• **HESITATION/STUMBLE—DURING ACCELERATION FROM LOW SPEED—VEHICLES BUILT FROM 3/15/1999 THROUGH 12/1/1999** • **LONG CRANK—VEHICLES BUILT FROM 3/15/1999 THROUGH 12/1/1999** • **MALFUNCTION INDICATOR LAMP ILLUMINATION—ENGINE MISFIRE—VEHICLES BUILT FROM 3/15/1999 THROUGH 12/1/1999** • **SURGING—DURING LIGHT LOAD, STEADY SPEED DRIVING—VEHICLES BUILT FROM 3/15/1999 THROUGH 12/1/1999** • **TRANSMISSION—5R55N—HARSH ENGAGEMENT—VEHICLES BUILT FROM 3/15/1999 THROUGH 12/1/1999** • **TRANSMISSION—5R55N—HARSH OR DELAYED SHIFTS—VEHICLES BUILT FROM 3/15/1999 THROUGH 12/1/1999**	**Article No. 99-26-1**

LINCOLN: 2000 LS

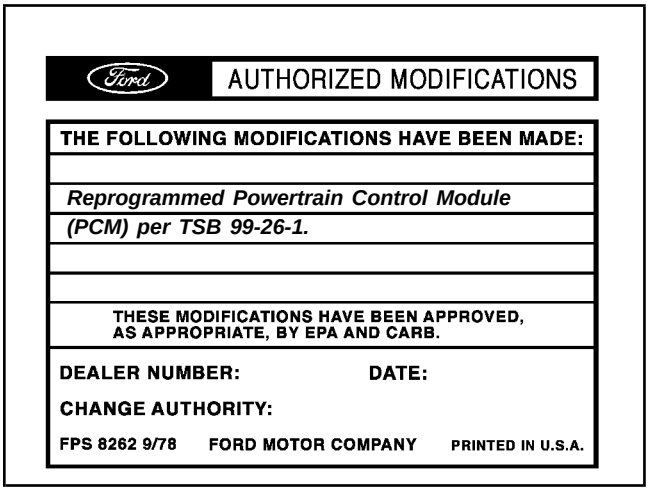
Obtain an Authorized Modifications Decal (FPS 8262 - obtainable through DOES II, 25/pkg) and list the date, dealer number, and summary of modifications performed. Select a prominent place adjacent to the Vehicle Emission Control Information Decal suitable for installing the Authorized Modifications Decal. Clean the area, install the decal, and cover it with a clear plastic decal shield.
